**METROPOLITAN GOVERNMENT OF NASHVILLE AND DAVIDSON COUNTY**

**STAFF RECOMMENDATION**  
**Fourth Avenue North and Van Buren Street**  
**May 21, 2014**

**Application:** New construction-infill

**District:** Germantown Historic Preservation Zoning Overlay

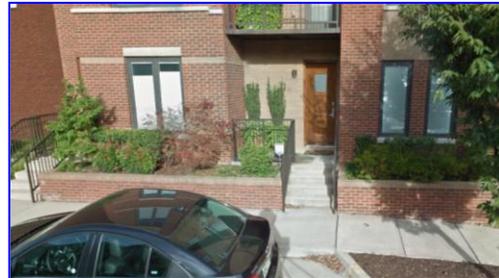
The existing portion of the development is to the left and the open space to the right will be building #2.

**Site and Building Planning:** The proposed development continues the siting and setbacks of the existing development, bringing the corner building close to the side walk to create an anchor. Pedestrian activity is encouraged with doors facing the street and vehicular access to the interior of the development. The project meets section 3.2.
